FILE BRST-219-1(1) Chatham County
P. I. No. 533205

SUBJECT **PROJECT CONCEPT REPORT APPROVAL**(CORRECTED)

SUBJECT: **CONCEPT REPORT**

PROJECT CONCEPT REPORT

STATE OF GEORGIA DEPARTMENT OF TRANSPORTATION OFFICE OF URBAN DESIGN	TYPICAL SECTION MONTGOMERY CROSSROAD OVER CASEY CANAL	DRAWING No.

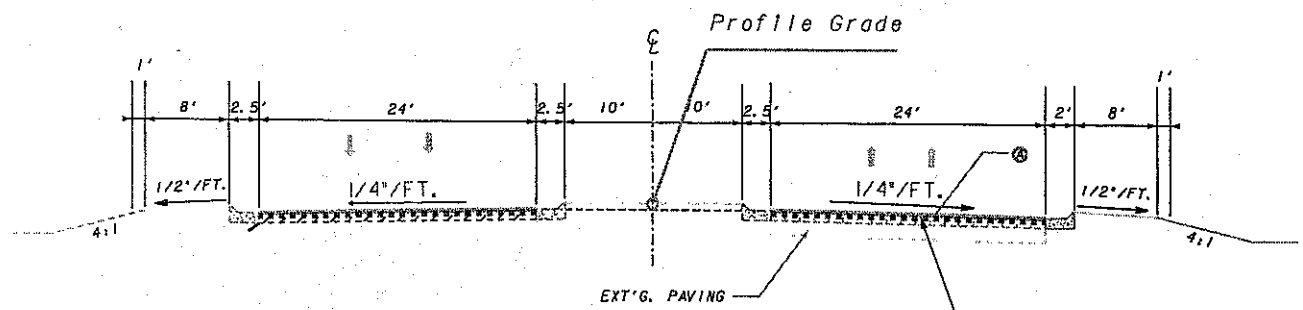
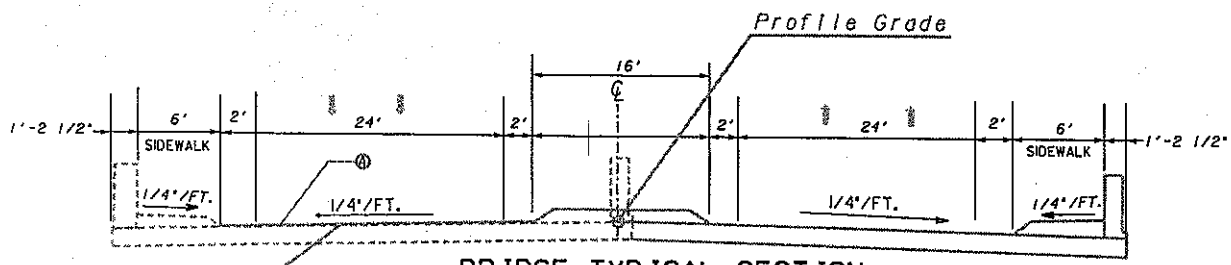
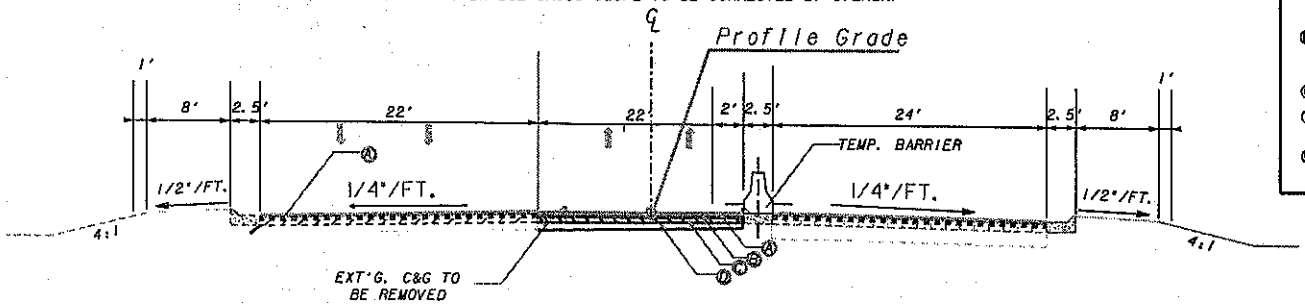
- Estimated Right of Way and Utility costs should be provided for informational purposes.
- ~~According to the Concept Report CR-302 is included in a Statewide Bicycle Plan. The roadway and bridge typical sections should reflect the current design features to accommodate the bike lane.~~

FOCUS AREAS	SCORE	RESULTS
Presentation	90	Estimated right of way and utility relocation costs should be provided for information. Roadway typical section does not appear to reflect the width required for bike lanes.
Judgement	100	
Environmental	100	
Right of Way	100	
Utility	100	
Constructability	100	
Schedule	100

CR 302 IS NOT ON THE STATEWIDE BICYCLE PLAN
— 11/19/2002
